## **ADDENDUM #4**

### **Rye City School District**

#### **Osborn Elementary School**

#### **Midland Elementary School**

4 EXTERIOR PANEL DESIGN ELEVATION B2  
SCALE: 1/4" = 1'-0"

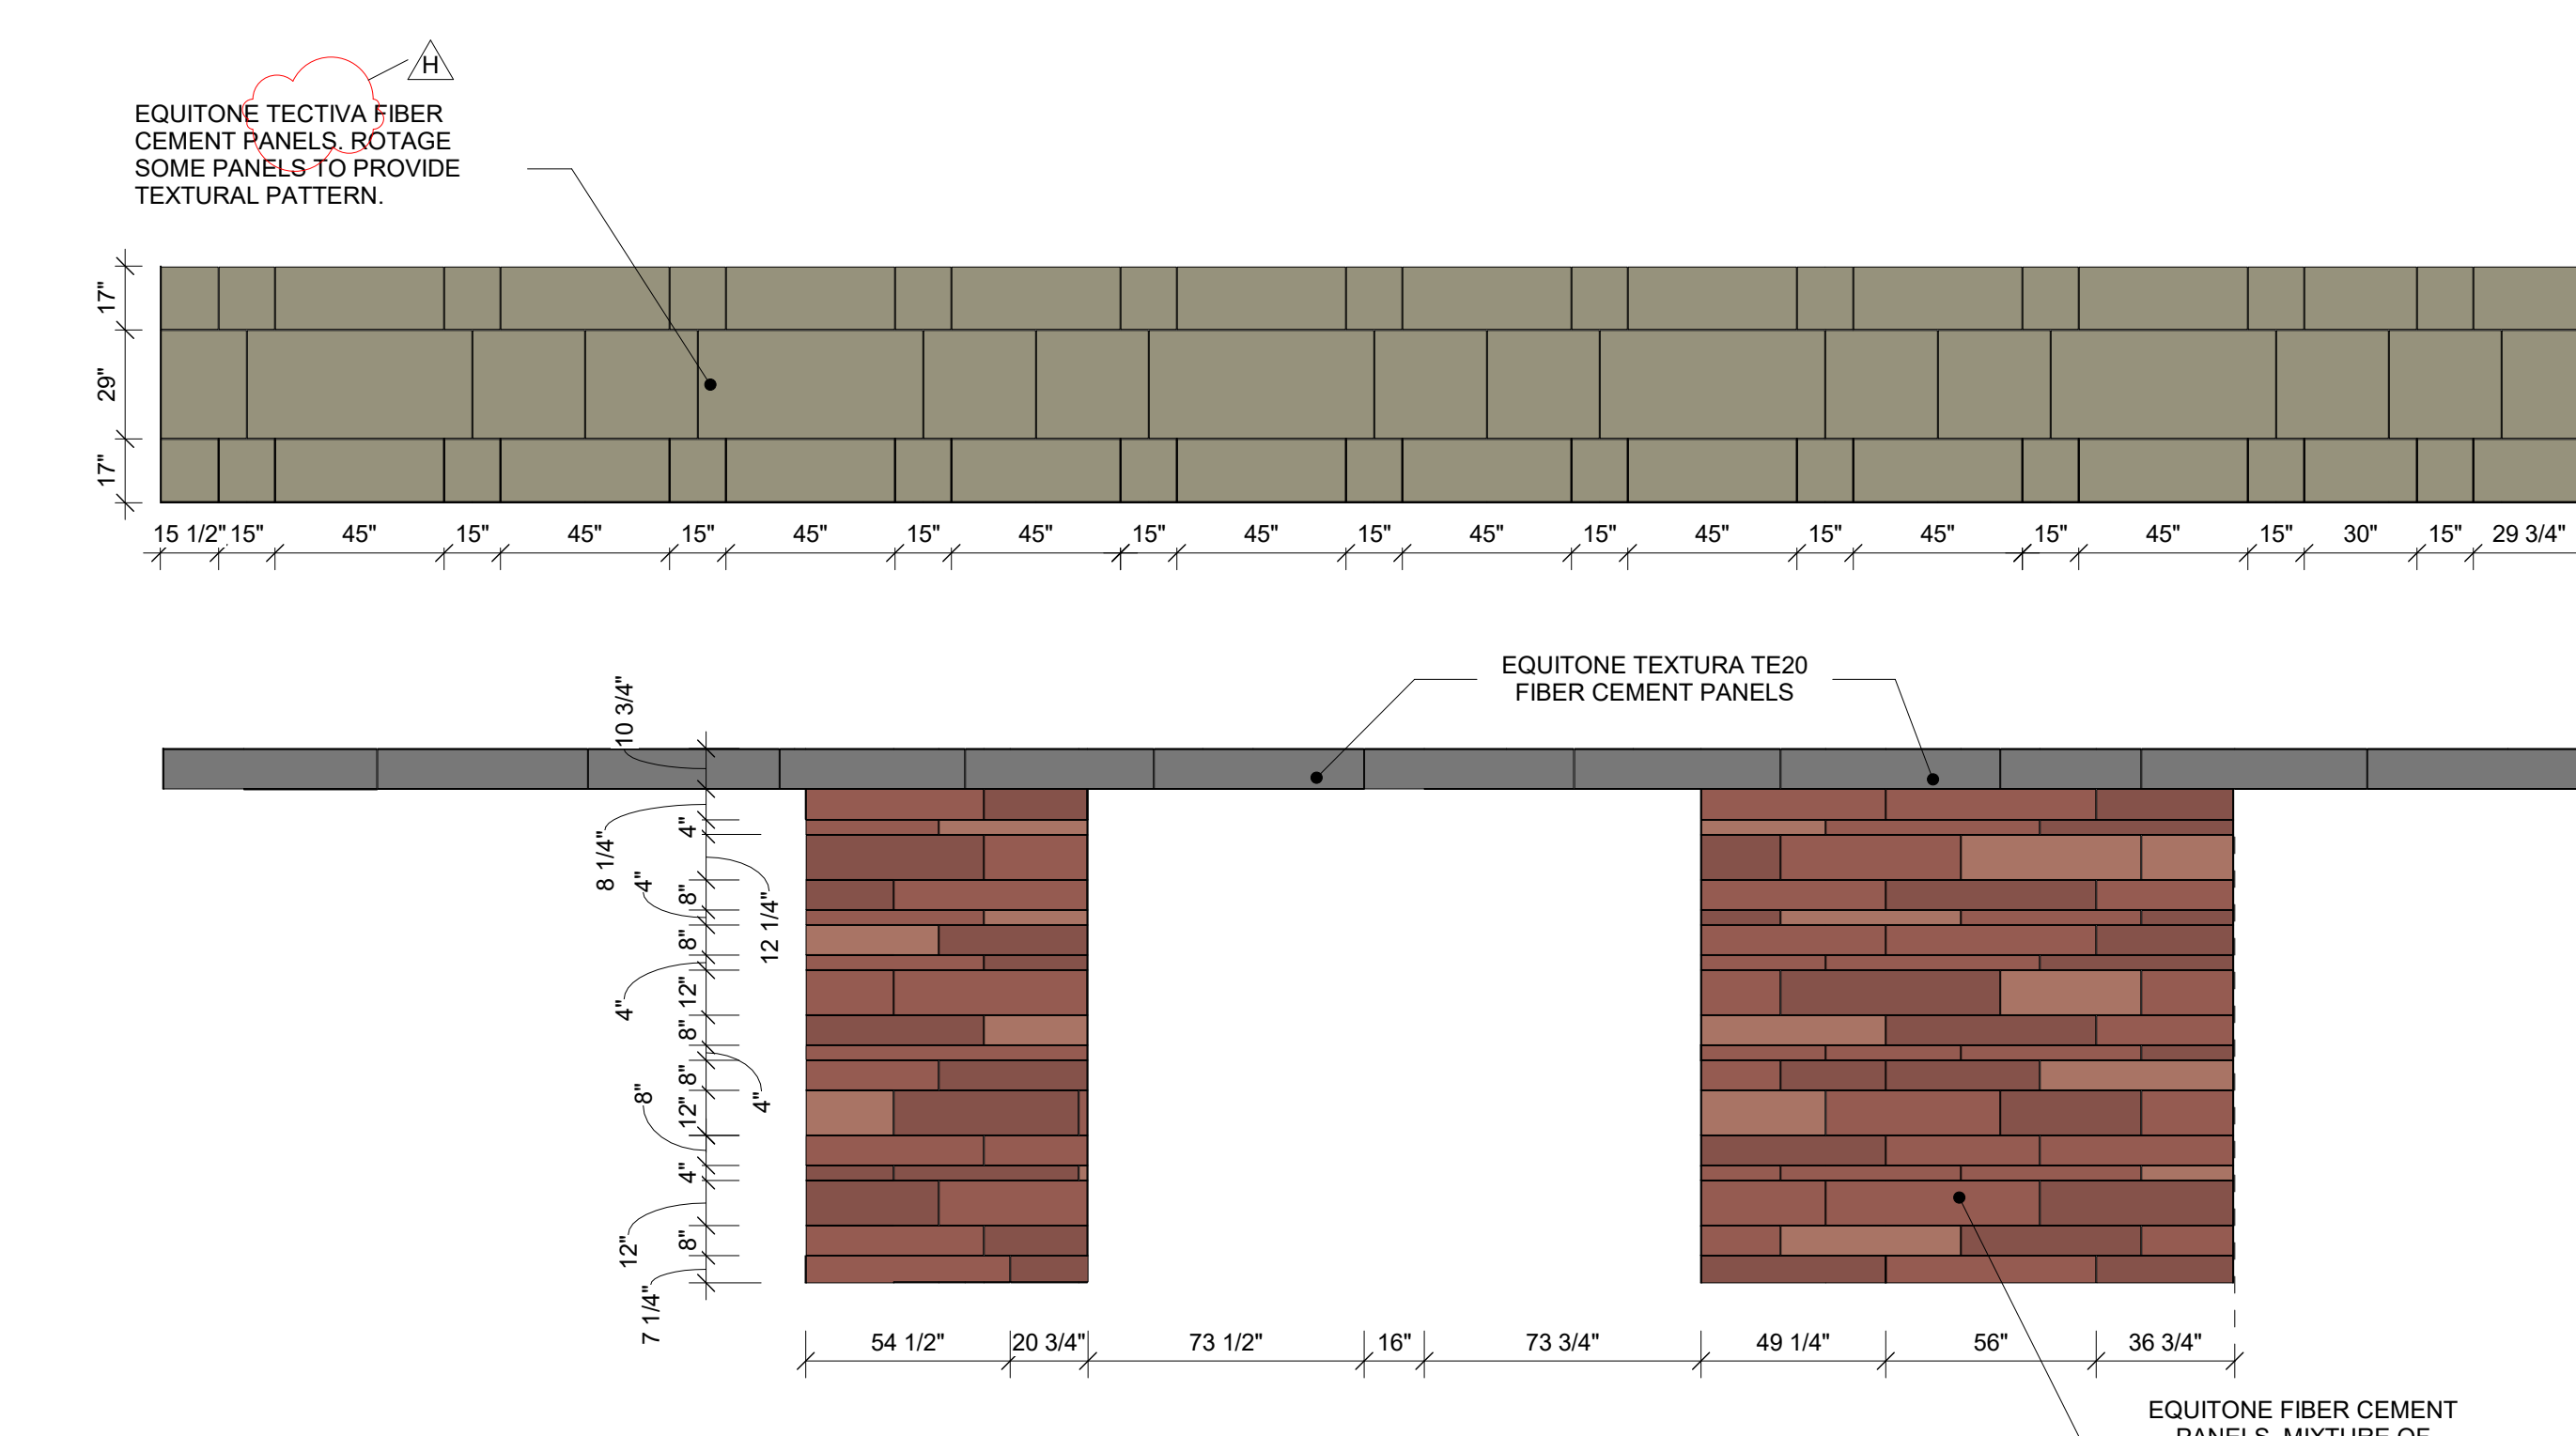
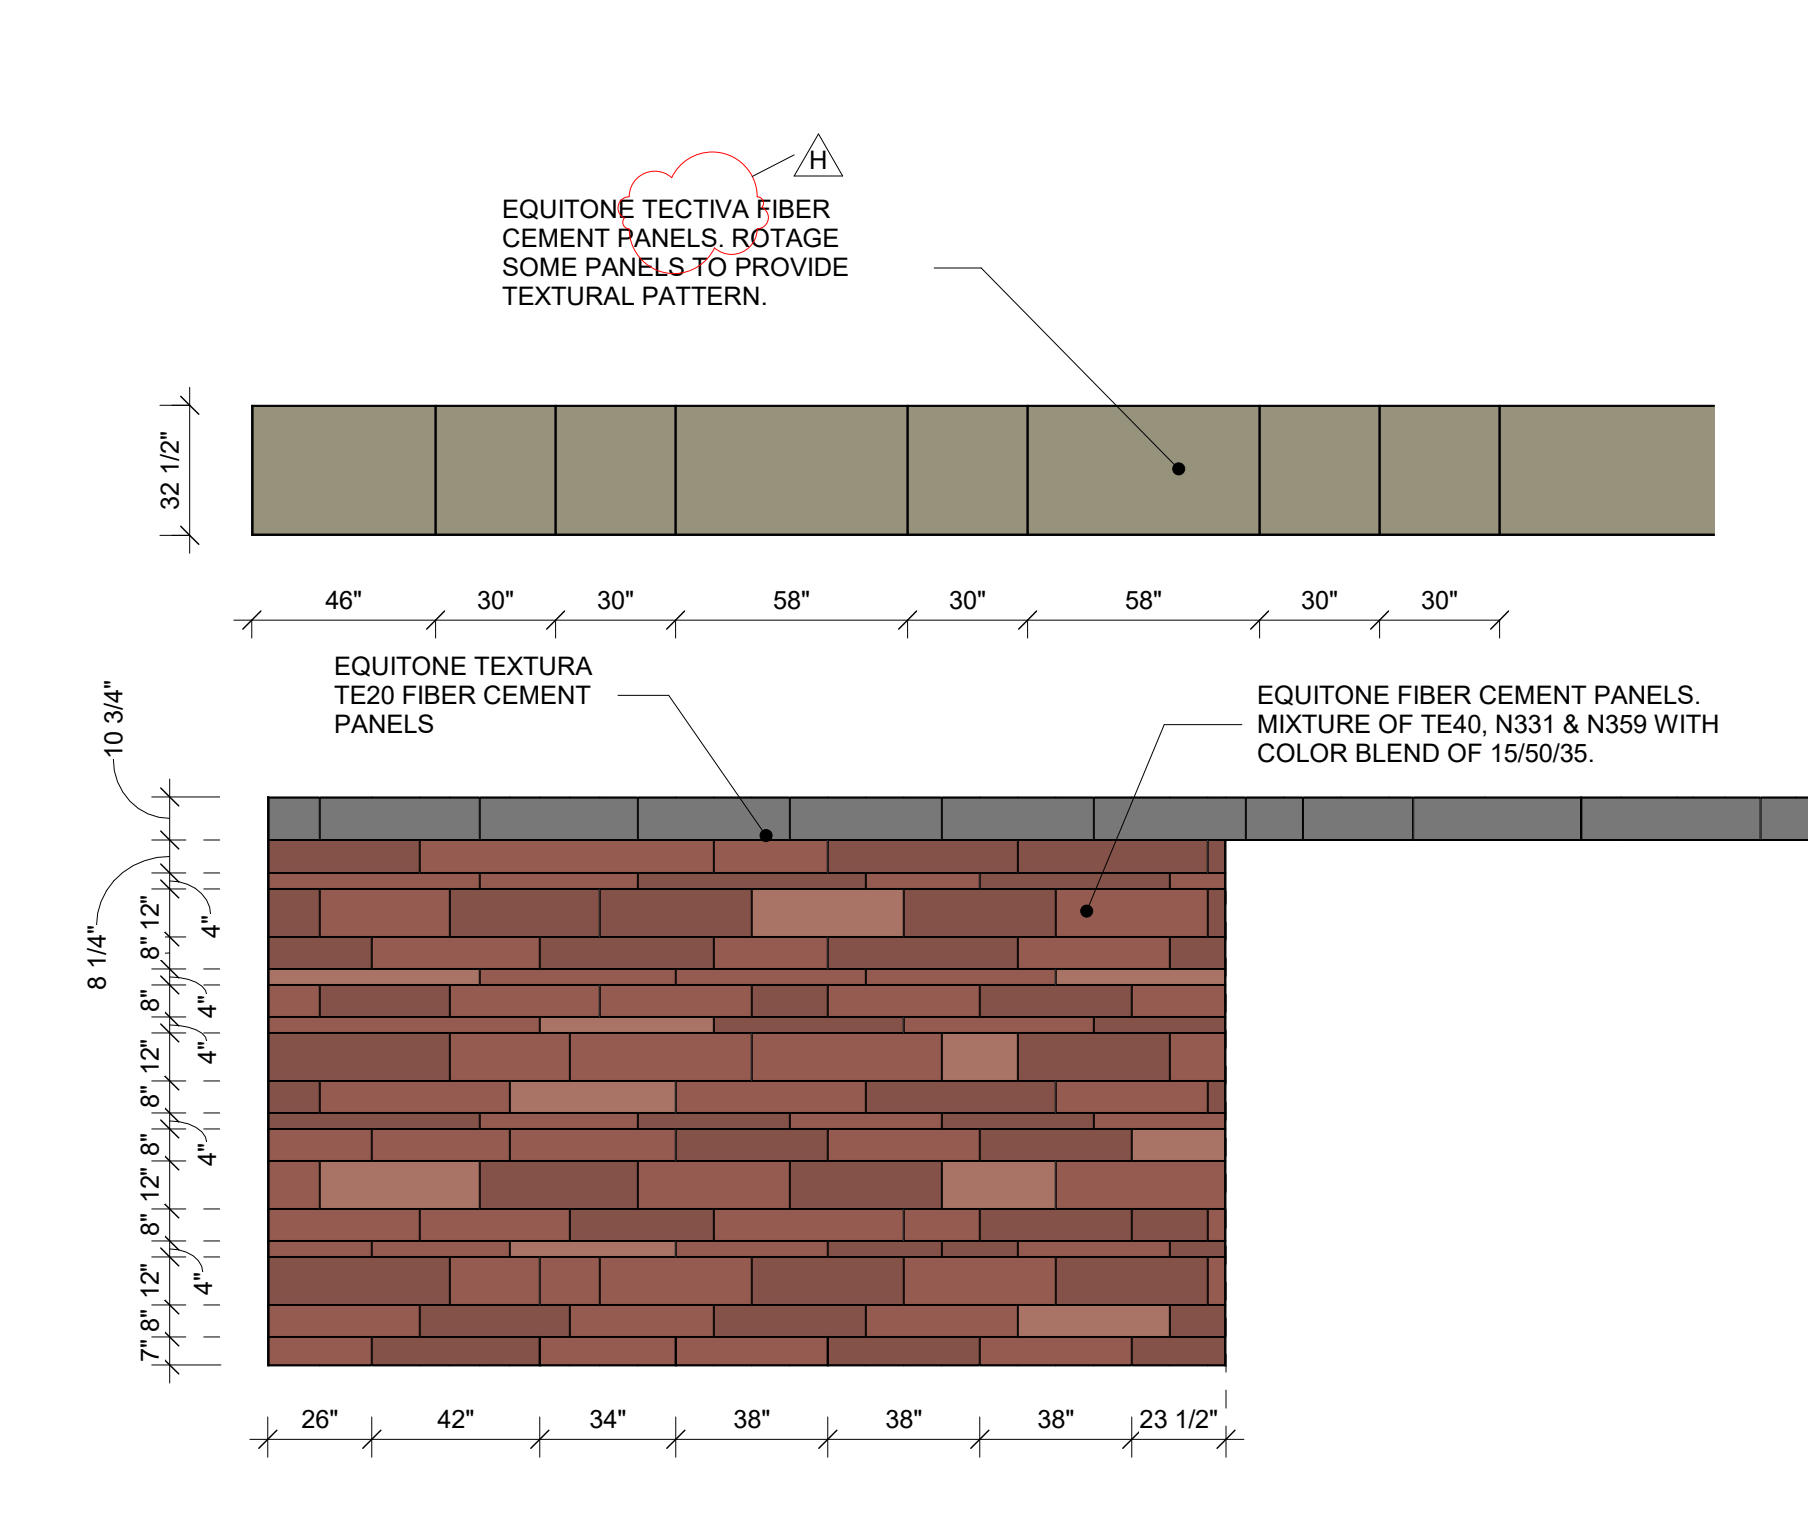
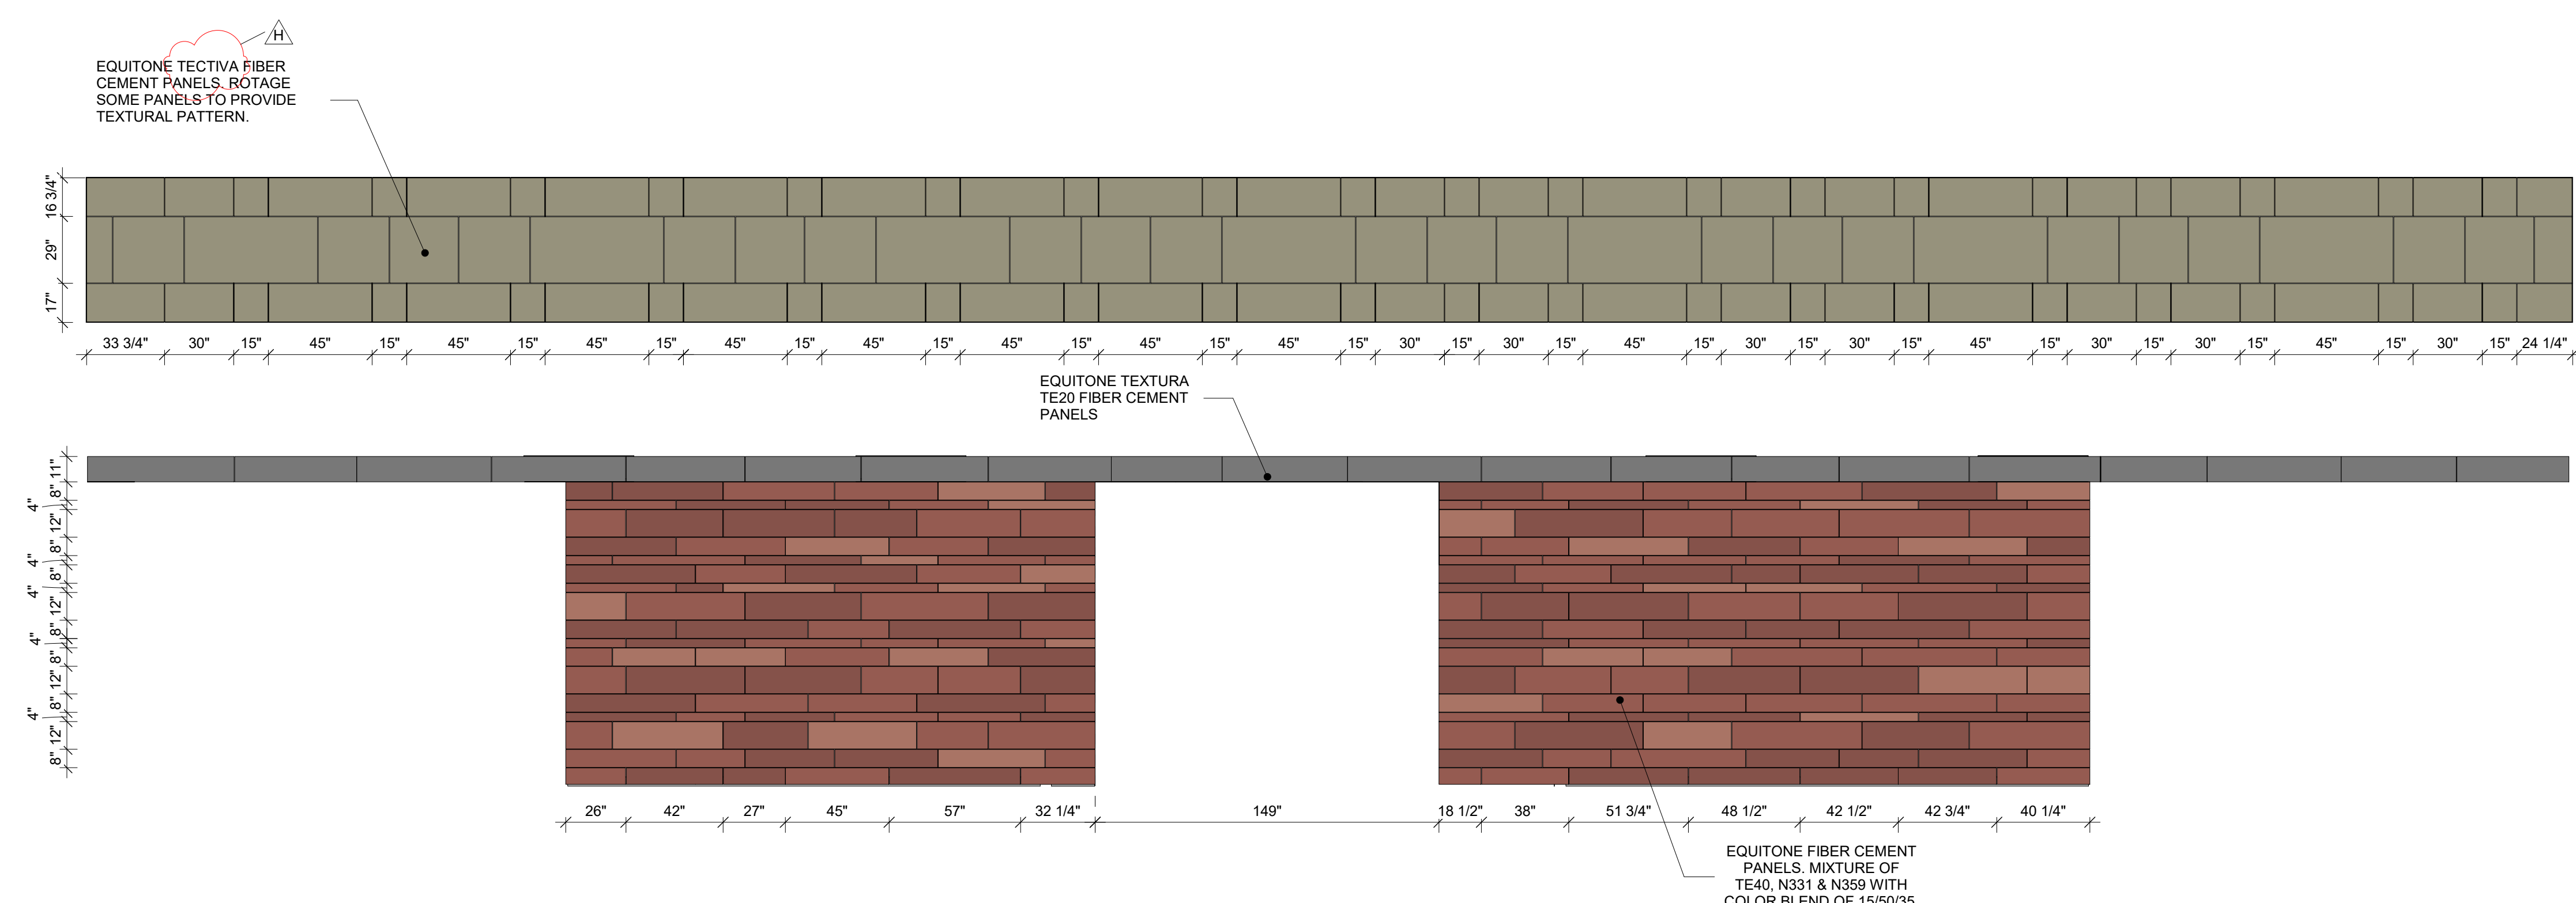
4. **Question:** Equitone fiber cement product is no longer available. Please advise.  
**Answer:** Only equitone materia line is discontinued. Drawings updated and included in this addendum to show equitone tectiva in locations where materia was previously indicated.
